Proposed Revisions to a Standard Plans Index

Index Number: 676-010

Index Title: CABINET INSTALLATION DETAILS

INDEX	SHEET
676-010	3
	1 of 1

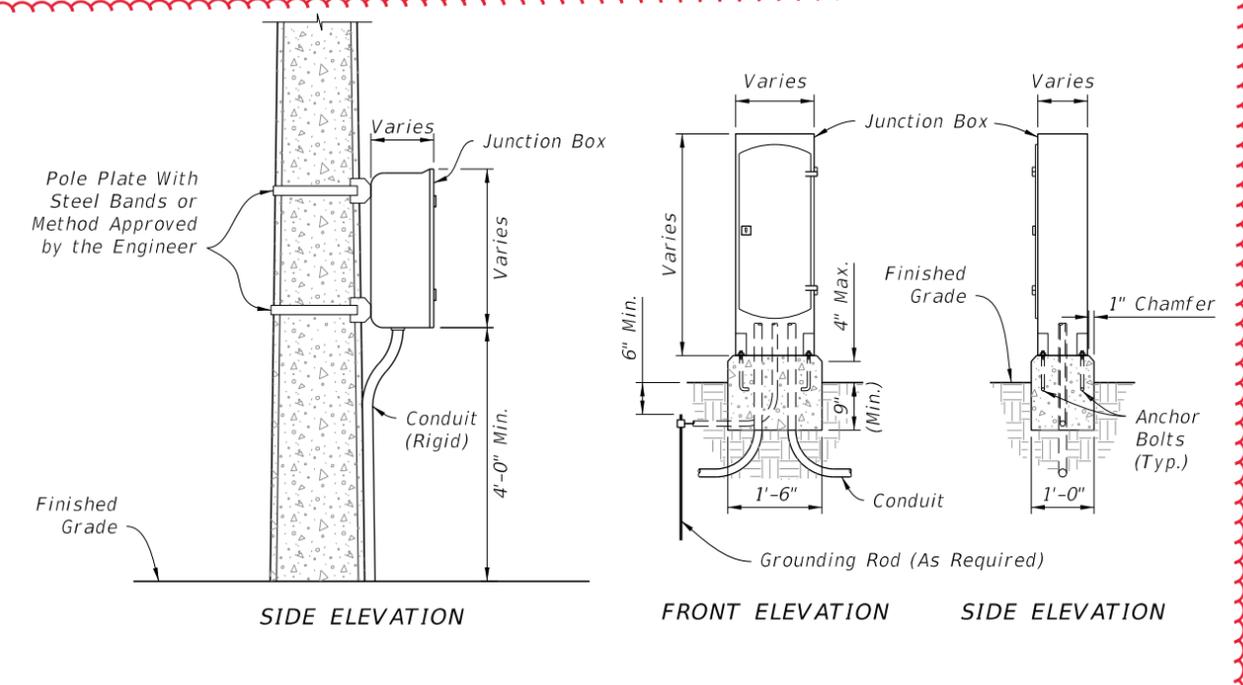
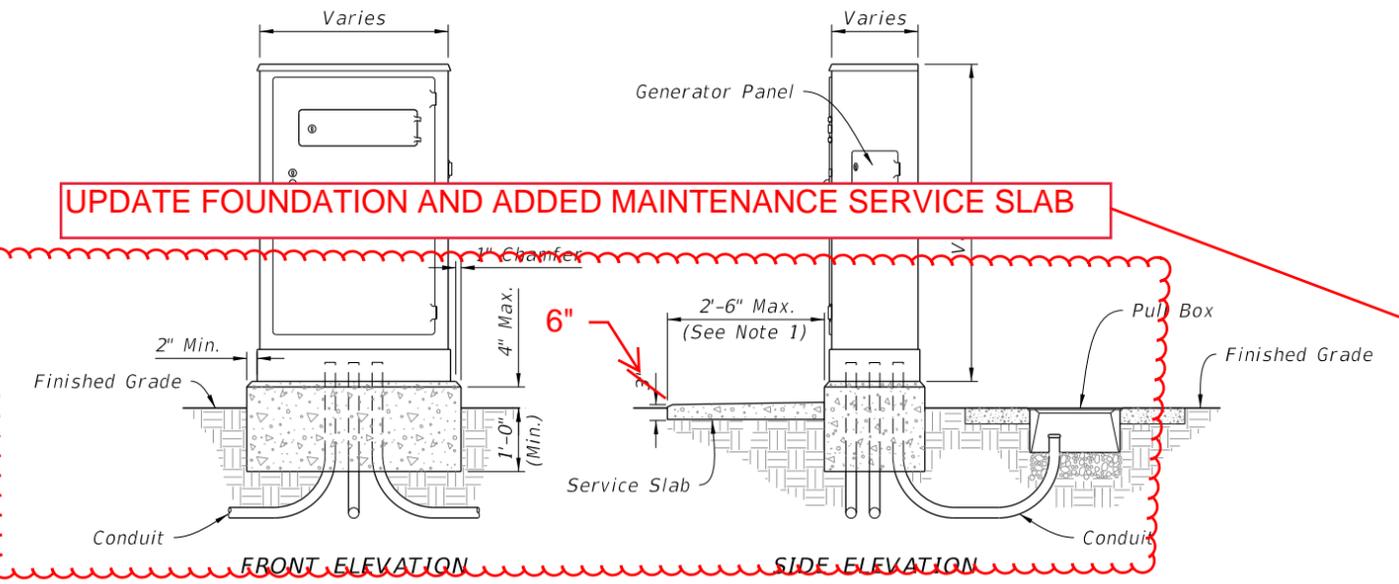
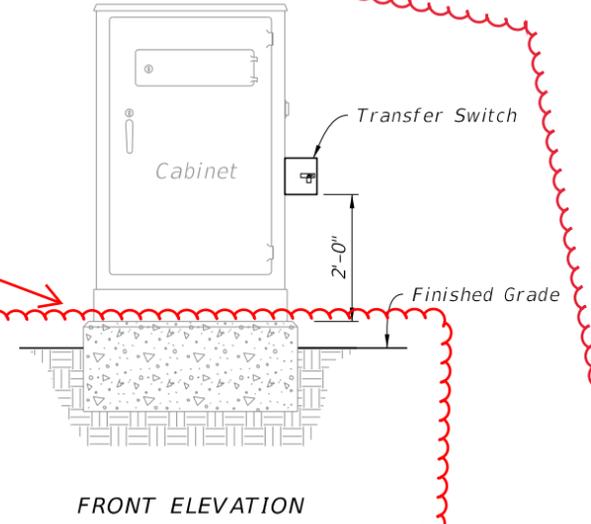
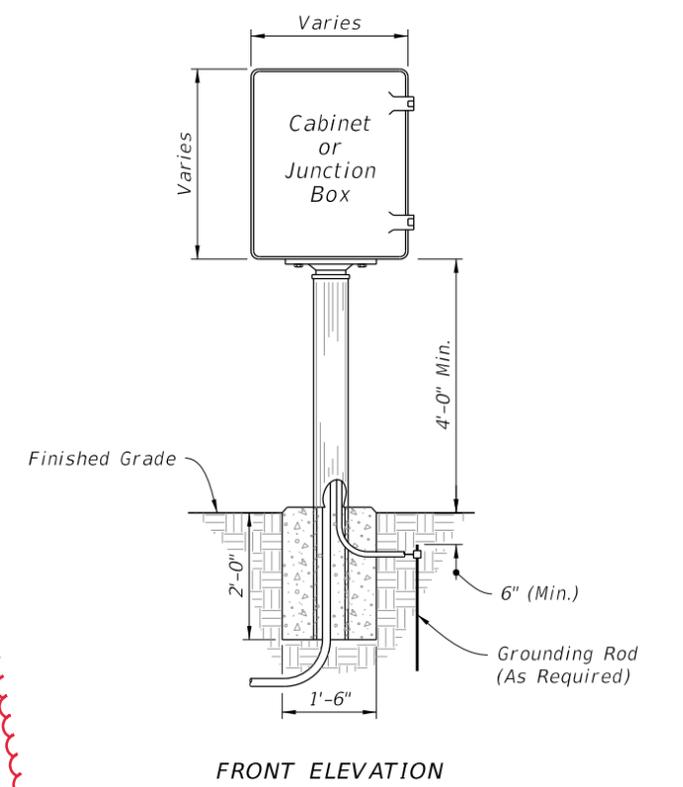
Sheet 1: Changed concrete thickness in the GROUND and POLE MOUNTED CONTROLLER CABINET detail; Added Maintenance Service Slab; Updated Notes; Renumbered sheet.

MOVED TO SHEET 3

UPDATED NOTES

UPDATED NOTES

NEW SHEET 2

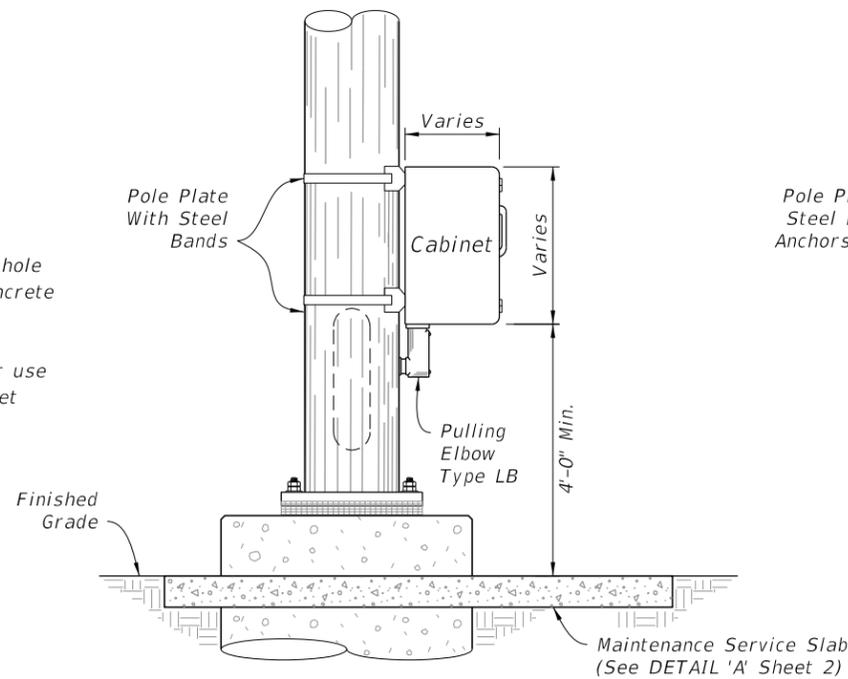
Sheet 2: New Sheet - details for Intelligent Transpiration System (ITS) cabinets and service slab requirements.
